**Subject: MHI's Response to US-APWR DCD RAI No. 590-4753 REVISION 0**

**US-APWR Design Certification  
Mitsubishi Heavy Industries  
Docket No. 52-021**

**RAI NO.:** NO. 590-4753 REVISION 0  
**SRP SECTION:** 16 - TECHNICAL SPECIFICATIONS  
**APPLICATION SECTION:** 16  
**DATE OF RAI ISSUE:** 6/8/2010

**QUESTION NO.: 16-301**

**Figure 5-7 Periodic Surveillance of Protection Functions Implemented via Binary**

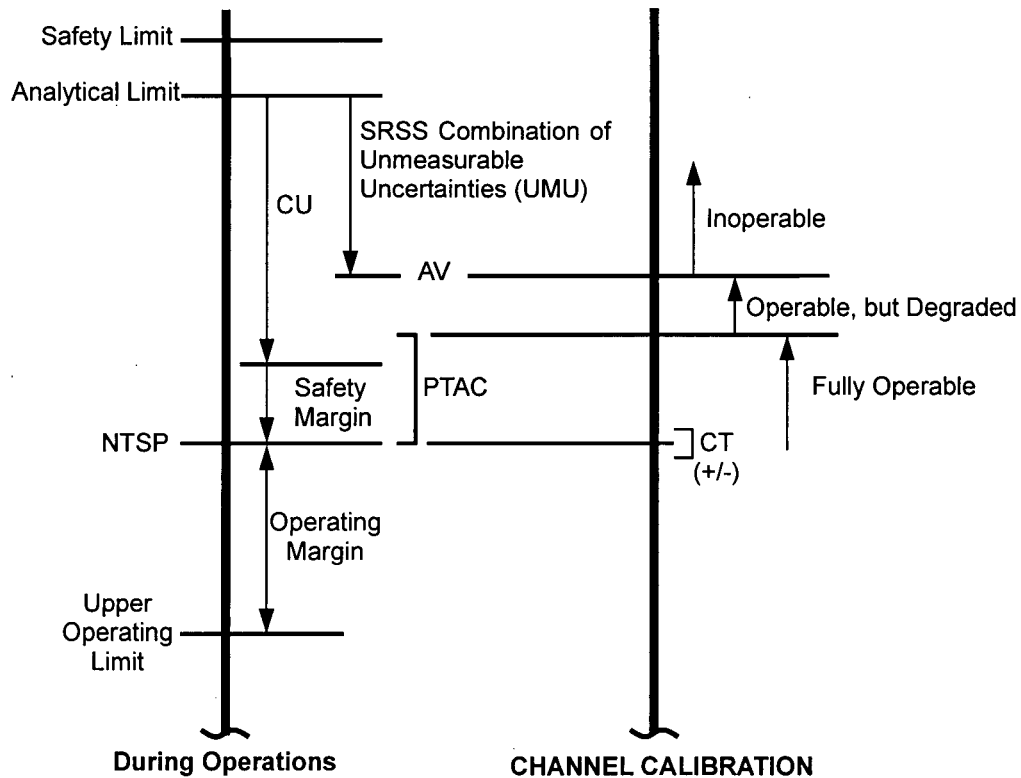
6. MUAP-09022-P(R0), "US-APWR Instrument Setpoint Methodology," states that the Loss of Power (LOOP) Function is implemented via a conventional analog bistable and that a Channel Operational Test (COT) confirms bistable accuracy. Table 3.3.2-1 on page 3.3.2-17 does not specify a COT SR for Function 6.e, LOOP Signal.

- a. Step 5.5.21.d states: "[f]or each Technical Specification required automatic protection instrumentation function implemented with an analog bistable function, performance of a CHANNEL CALIBRATION surveillance ..." MUAP-09022-P(R0), "US-APWR Instrument Setpoint Methodology," states that a Channel Calibration confirms the instrument accuracy over its entire range and that a COT confirms analog bistable accuracy. Determine the correct SR to be specified for analog bistable functions in step 5.5.21.d.

Sections 5.3.1 and 5.3.2 of MUAP-09022-P(R1) are incorrect. MHI will revise sections 5.3.1 and 5.3.2, and add a new section 5.3.2.2 with a new Figure 5-7 in MUAP-09022 (please see “Impact on DCD”).

a. MHI will revise sections 5.3.1 and 5.3.2 of MUAP-09022 and add a new section 5.3.2.2 with a new Figure 5-7 in MUAP-09022.

Figure 5-7 illustrates the relationships between the trip setpoint and other parameters for

protection functions implemented via binary sensors connected to digital PSMS channels. These functions are 1) reactor trip (RT) on turbine trip (TT) via low turbine oil pressure (pressure switch) and 2) Loss of Power (LOP) signal (UV relay).

Binary sensors connected to PSMS are surveilled the same way as analog sensors connected to PSMS, whereby channel calibration confirms the complete channel accuracy in one step for periodic surveillance, with the exception that channel accuracy is checked at the binary sensor trip setting. AV, PTAC and CT limits are therefore applied to the NTSP.

The AV is used during channel calibration to determine operability. The PTAC term is described in Section 5.4. PTAC is used (relative to NTSP) to determine degradation, thus avoiding the use of excessive tolerances as required by Reference 3.2.4 (RIS 2006-17). Plant procedures will reflect this approach (increasing process; invert for decreasing process):

- If the as-found trip value is less than NTSP + PTAC, then the channel is fully operable
- If the as-found trip value is greater than NTSP + PTAC and less than AV, then the channel is operable but degraded, and corrective action is required to restore the channel to within specifications.
- If the as-found trip value is greater than AV, then the channel is inoperable, and corrective action is required, including those actions required by 10 CFR 50.36 when automatic protective devices do not function as required.
